SN65LVPE502A/ SN65LVPE502B

Application Note

The SN65LVPE502A redriver and SN65LVPE502B redriver are dual channel, single lane USB 3.0 redrivers and signal conditioners supporting data rates of 5.0Gbps. All errata for the previous part, SN65LVPE502CP, are fixed in these devices. This application note provides information on implementation of the SN65LVPE502A/SN65LVPE502B devices based on changes from the SN65LVPE502CP device.

Figure 1 SN65LVPE502A/ SN65LVPE502B Pin-Out

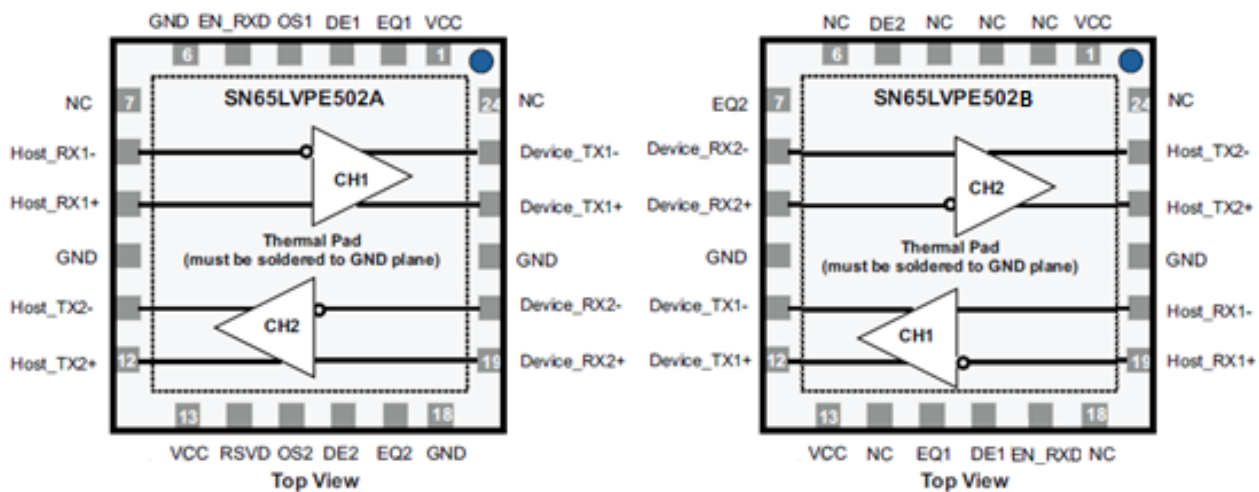
The host side and device side connections are now defined for the SN65LVPE502A and SN65LVPE502B devices. Please reference Table 1 SN65LVPE502A Pin Functions, for a list of pin definition changes.

Figure 4 Connection of VBUS Powered Device

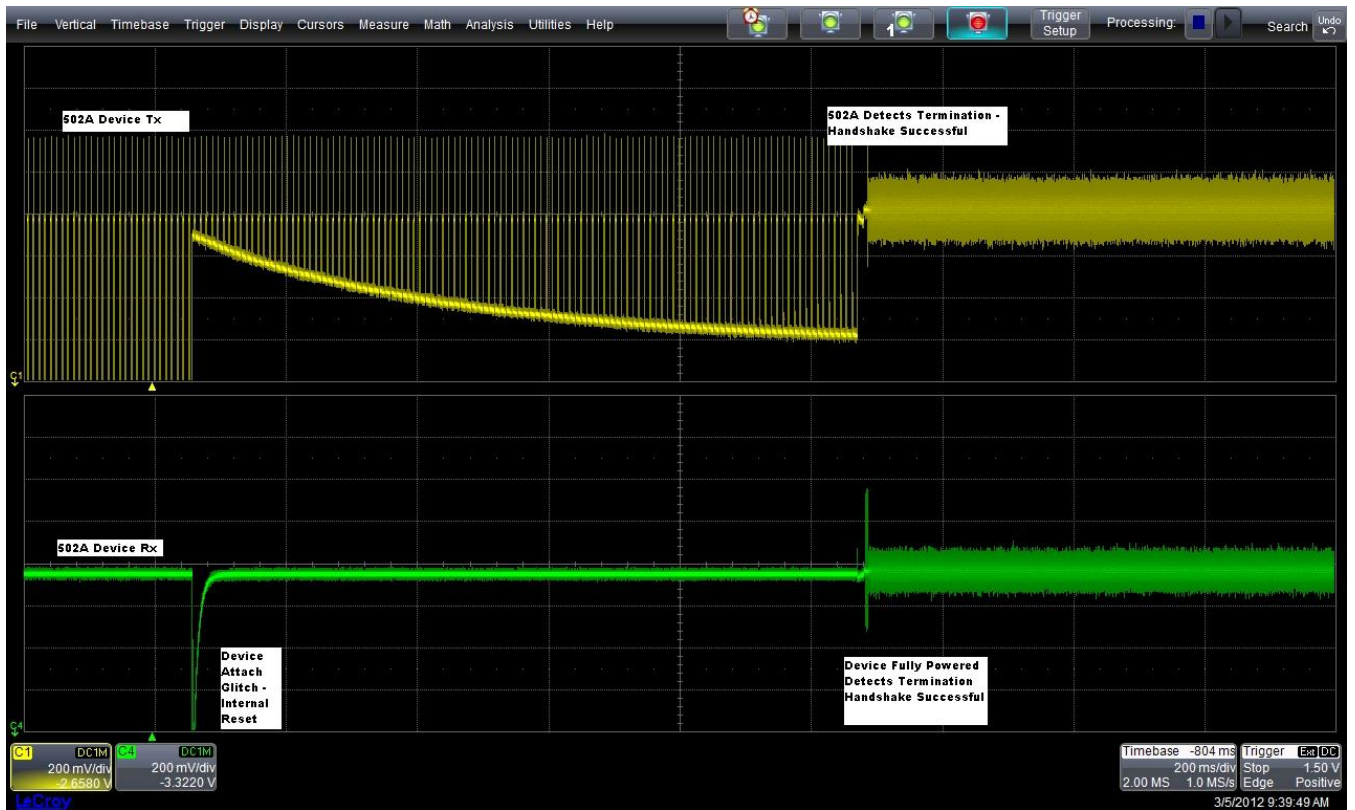
Some VBUS powered devices create noise on plug-in and cause the SN65LVPE502CP to falsely detect the device and enable termination early. After termination is enabled, the host begins polling before the device is ready. Polling will timeout and the host will enter compliance mode. This issue is fixed on the SN65LVPE502A device. Figure 2 Connection of VBUS Powered Device below shows a successful connection after a glitch is observed when the VBUS powered device is attached.

Figure 5 SN65LVPE502A Successful Disconnect

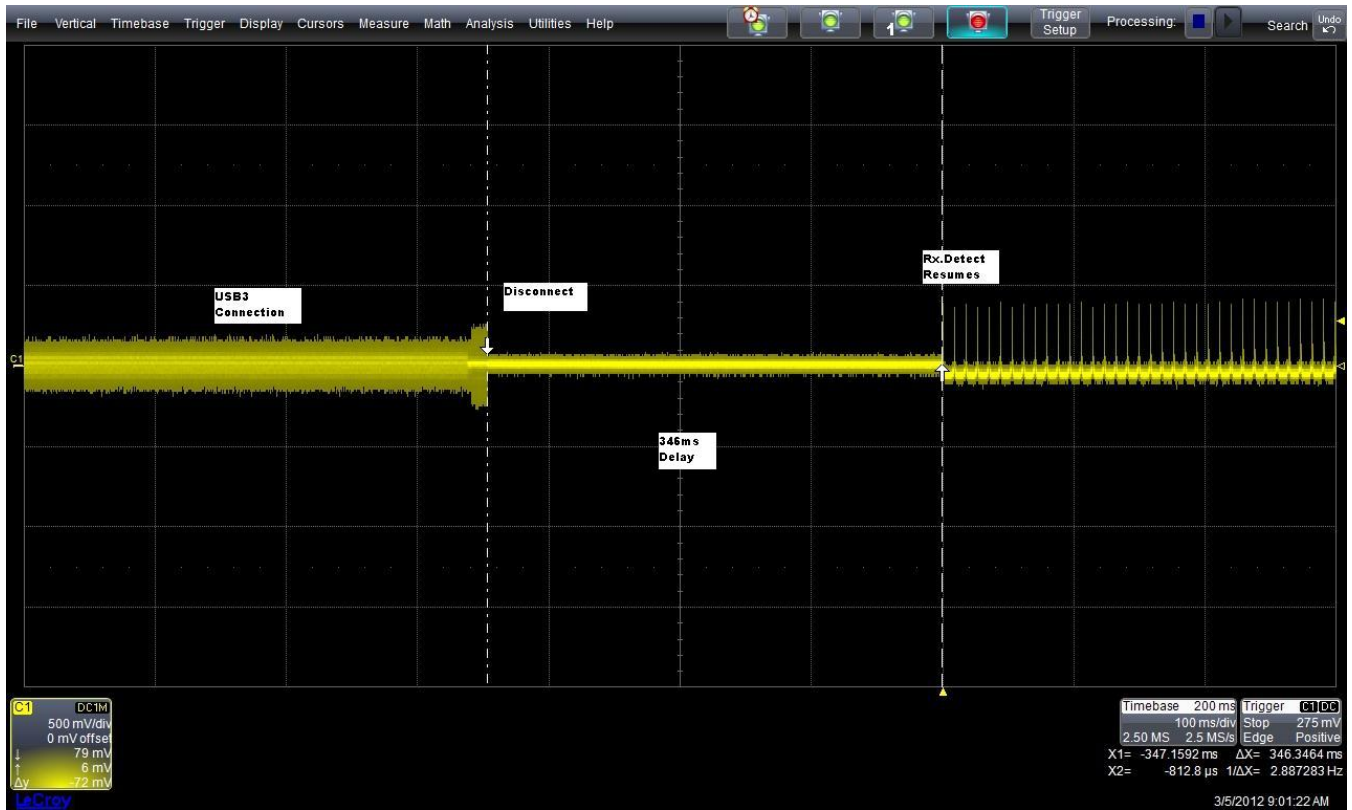
In certain conditions the termination remains enabled after a device is disconnected from the SN65LVPE502CP. This issue is host software driver dependant. If host issues a warm reset within ~300ms of device disconnect the termination will remain enabled. No functional issues are observed, but the power consumption is increased while no devices are connected. This issue is no longer driver dependant and is fixed in the SN65LVPE502A. A successful disconnect may be observed in Figure 3 SN65LVPE502A Successful Disconnect below.
